Dear Rotax Dealers,

Improvements of clutch drum 659154

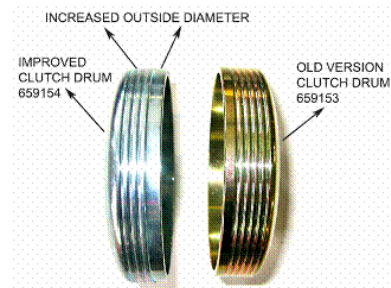
From reports which we received from the market we had to realize that the failure rate of clutch drum 659153 used on engine 125 MAX/Junior MAX is still not up to our quality expectations. Therefore we decided to introduce the improved clutch drum 659154.

- " New material and surface treatment (due to environmental laws)
- " Increased outside diameter
- " New outside shape

Due to the different surface treatment the colour of clutch drum 659154 is now silver. In order to reinforce the clutch drum the outside diameter has been increased by approximately 2mm and the outside shape, number of grooves, have been reduced to 3 grooves.
